SERVICE LETTER

No. 777

Piper Aircraft Corporation

Fin Front Spar Modification.

FIGURE 1

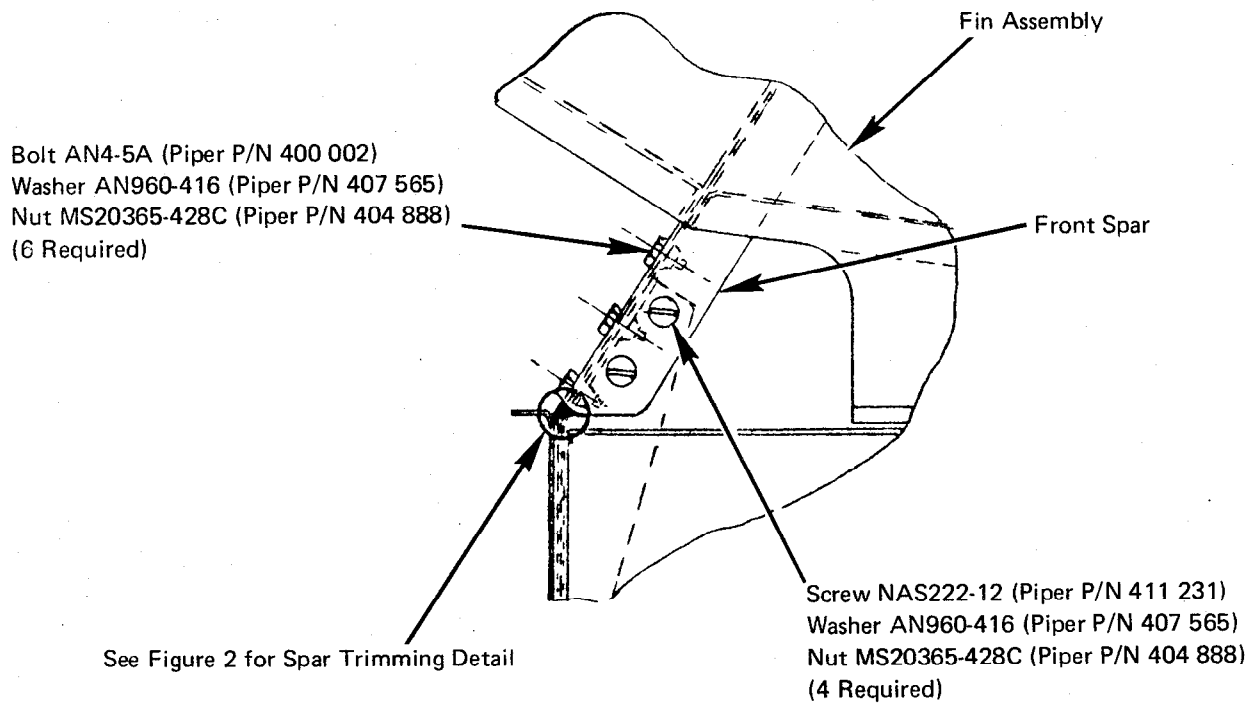
FAA Airworthiness Directive #75-12-06 dated June 5, 1976 required a repetitive inspection of the PA-24 Comanche series Fin Front Spar to Fuselage Attachment Channel bend relief holes for evidence of cracks; repair or replace cracked channels/straps if cracks are detected...etc. We have been advised that, in the near future, the FAA is planning a similar action relative to the PA-30 and PA-39 Twin Comanche series.

FIGURE 2

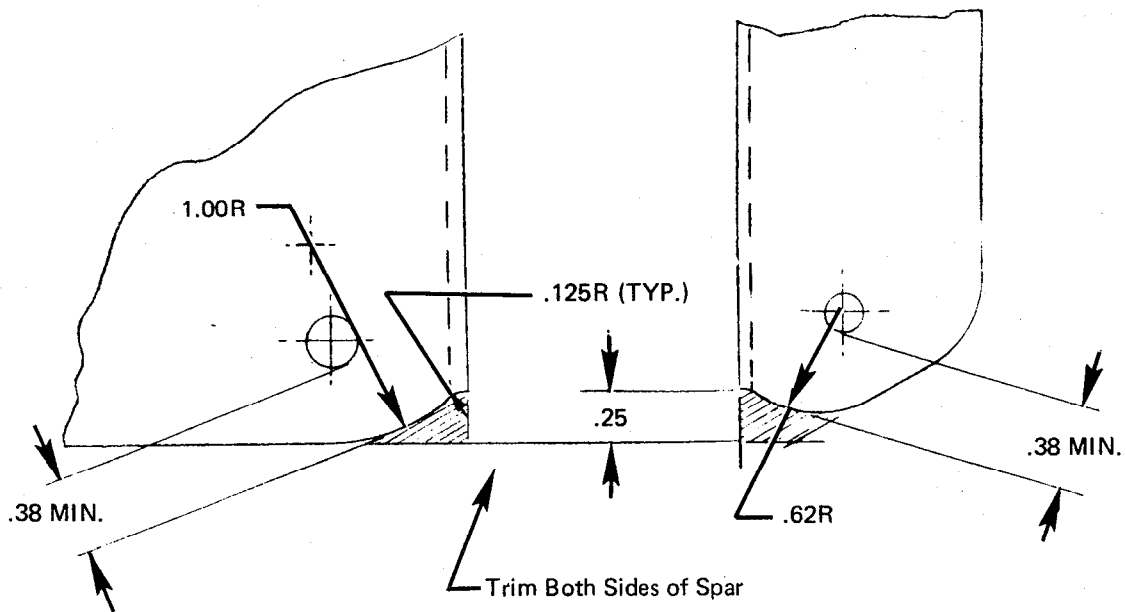
Since it is necessary to physically remove the Fin Assembly to gain visual access to the channel relief holes (as the Fin Front Spar extends over the relief holes approximately 1/2 to 2/3 of the relief hole diameter), this service release provides instructions to modify the Fin Front Spar to eliminate repetitive removal of the fin and to enable an easy visual inspection.

Refer to "Spar Trimming Detail" instructions on reverse side of this service release.
